Kansas Department of Agriculture  
 Division of Water Resources  
**CHANGE: P/U WORKSHEET**

RE: Change the Place of Use, File Nos; 5784 9281

## DWR FIELD OFFICE APPLICATION FOR APPROVAL TO CHANGE THE PLACE OF USE AND/OR THE POINT OF DIVERSION

# 5784 & 9281 PU change review

# Change in Place of Use: WR #9281

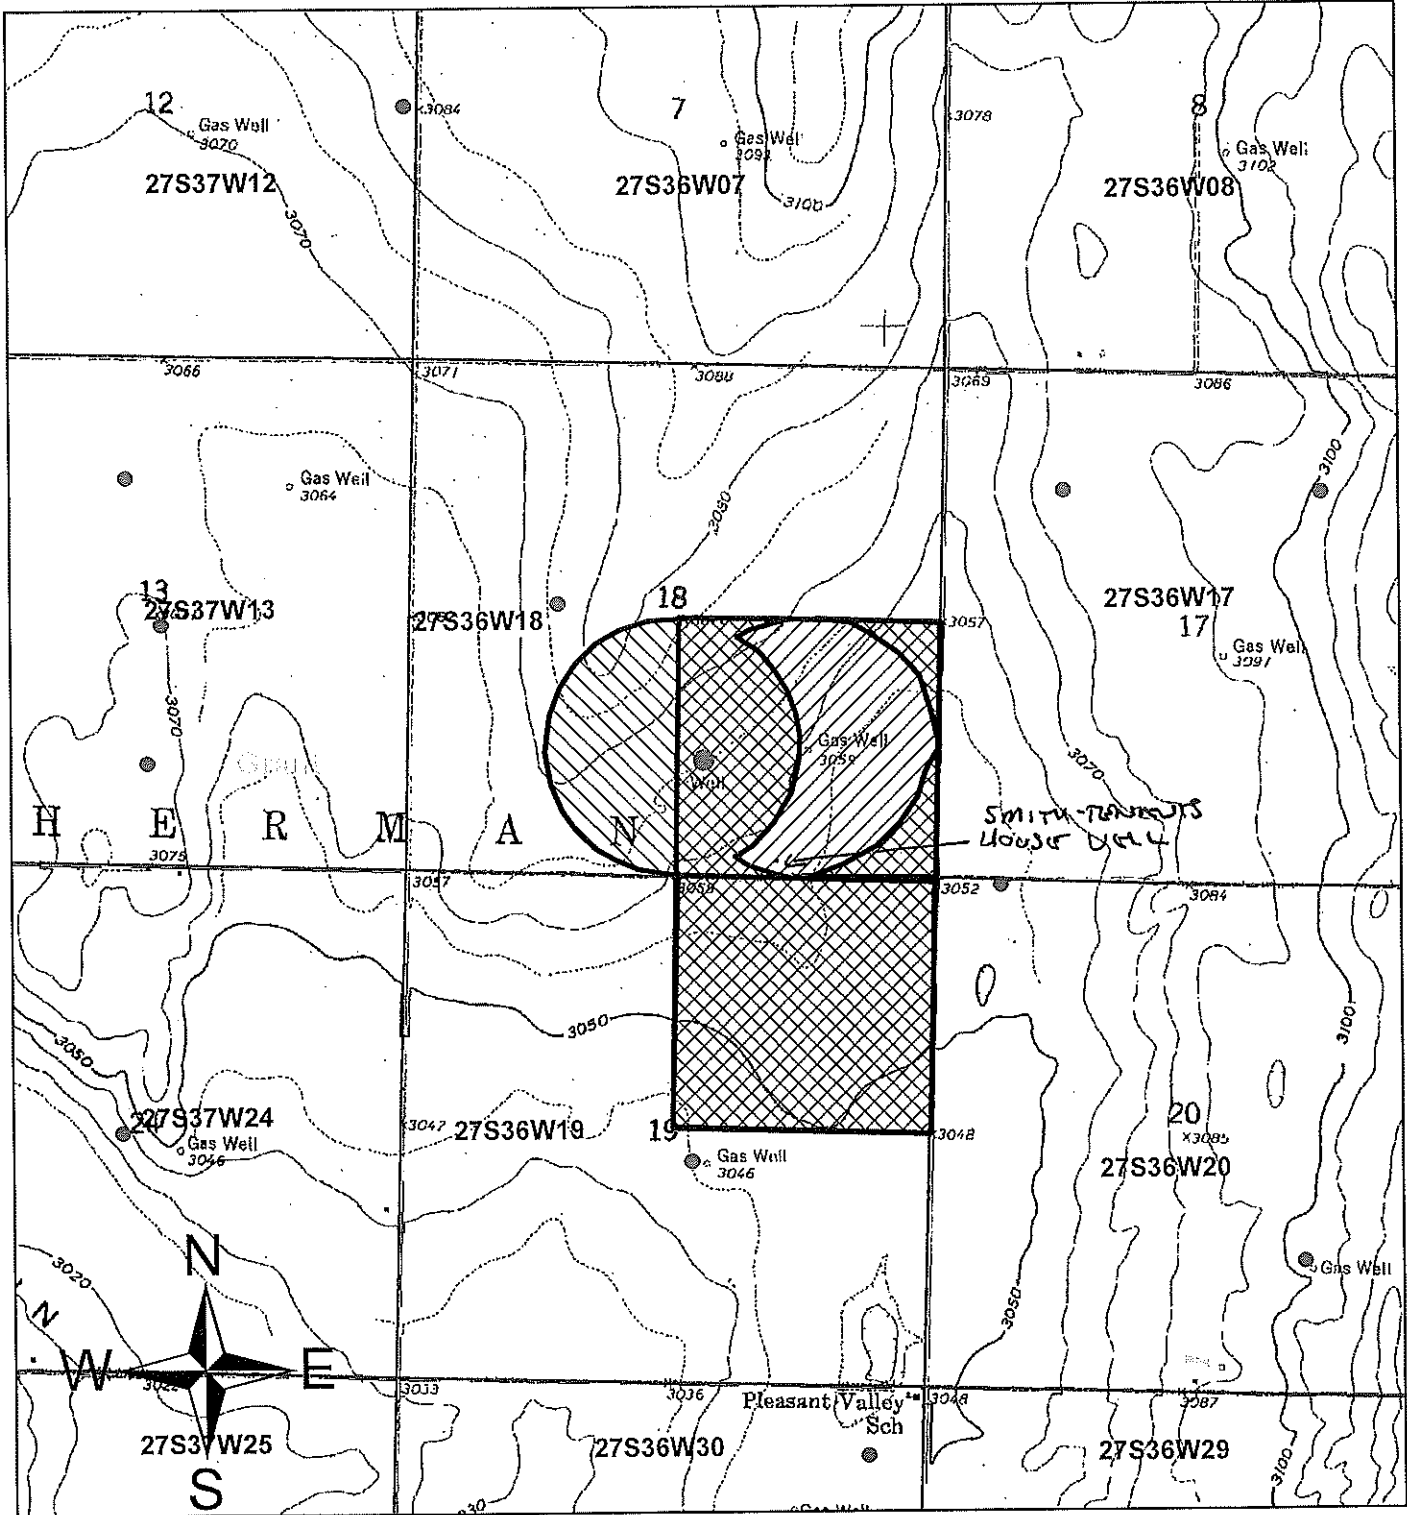
7. The changes herein are desired for the following reasons?  
 (please be specific) TO MOVE PIVOT TO BETTER GROUND + LEAVE CORNERS FOR FLOOD, & AVOIDS LONG STAY

We have completed a review of the applications for the above referenced water rights. The proposal is not in conflict with the Management Program of the Southwest Kansas Groundwater Management District No. 3 (GMD3). The proposed change in place of use, to shift the pivot in the SE quarter to the west so the homestead is no longer in the pivot circle, is in accordance with K.A.R. 5-5-11. It is therefore recommended that the applications be approved at this time.

- 2. On and after the effective date of this summary order, the authorized place(s) of use shall be located substantially as shown on the topographic map accompanying the application to change the place of use.  Applicable  Not Applicable

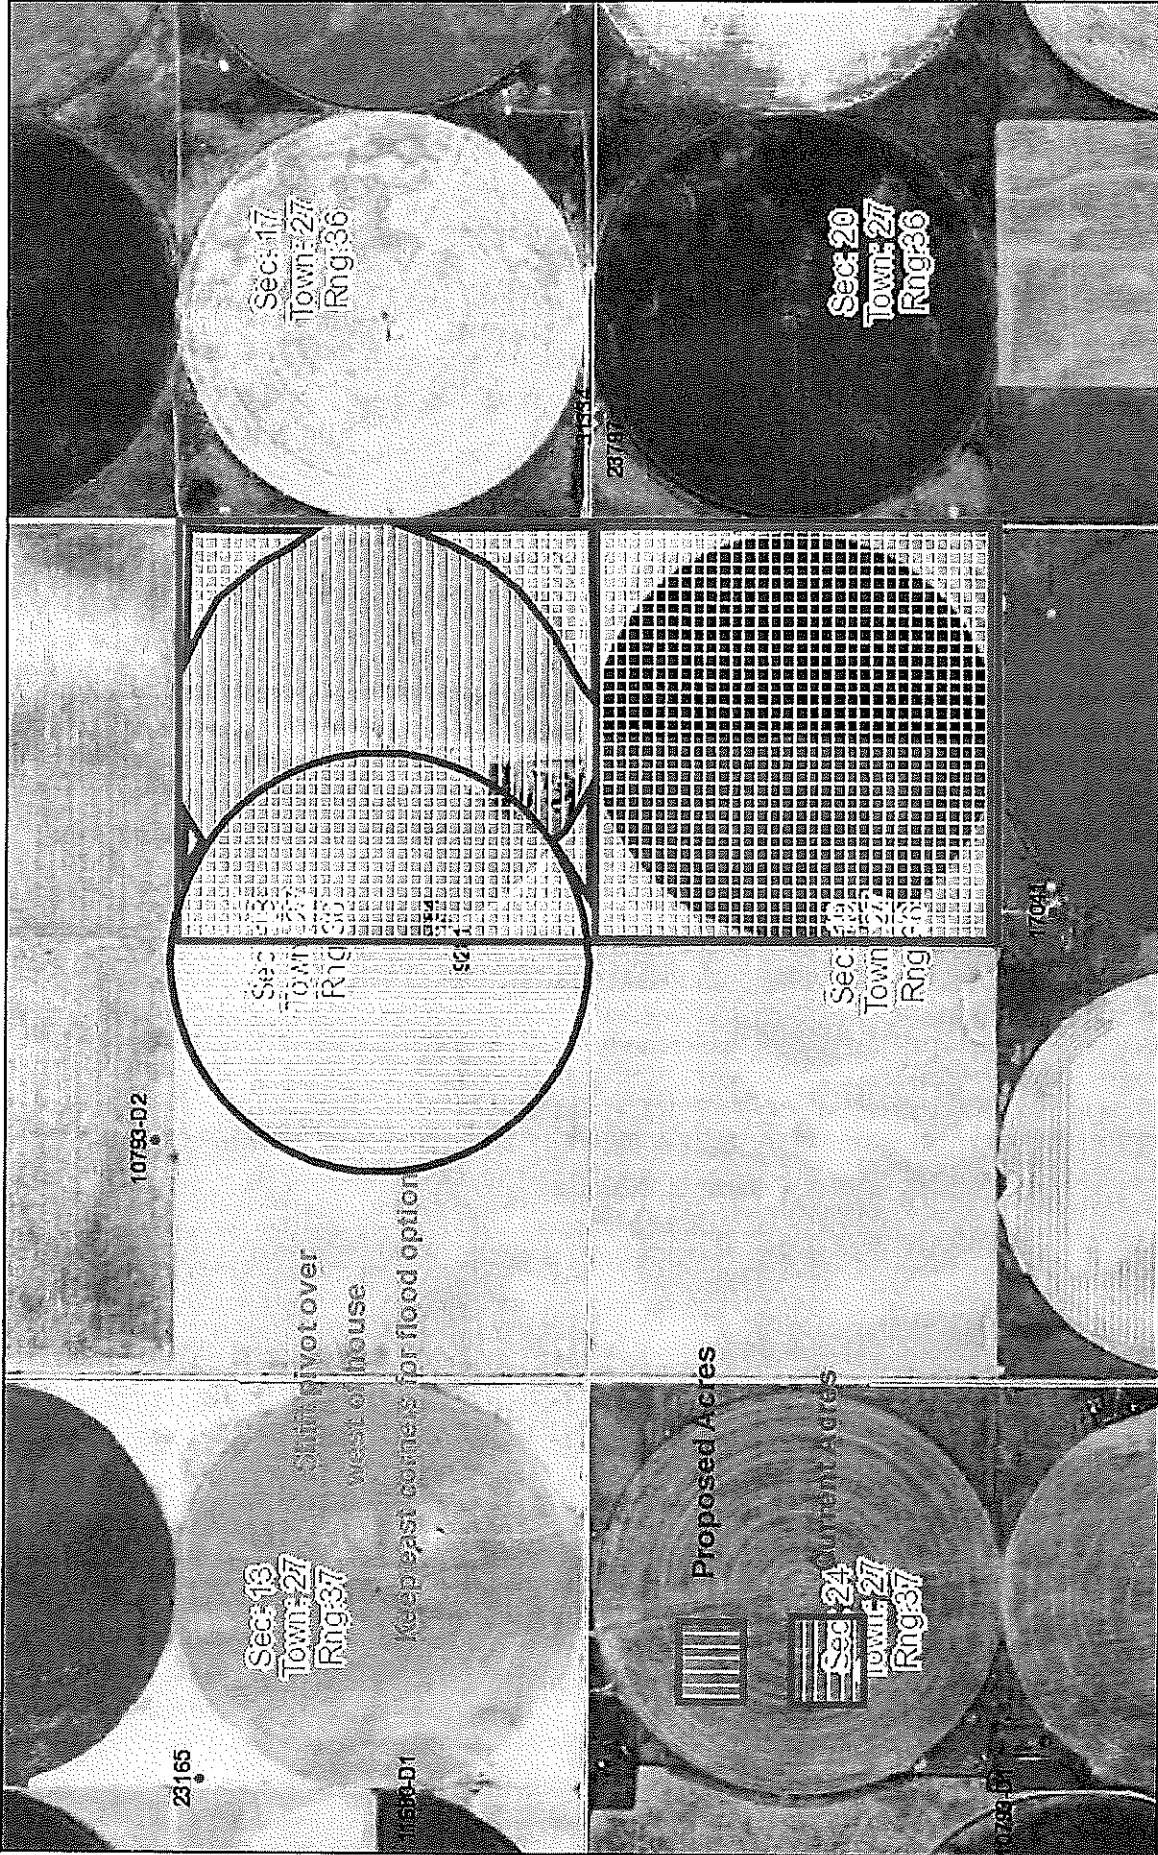
Is Proposed PU overlapping existing WRs? Altering acres and making a complete overlap. Currently not a complete overlap with these WRs.

**Applicant shifting one of the pivots to the west to utilize authorized acres and get the homestead out of the pivot circle. Wants to retain the ability to water the corners in the east half if desired.**

**Currently authorized 320AF and proposes 320AF**

Final Recommendation: After review of all available information, it appears the current area rules are met. Staff therefore recommends approval of the applications.
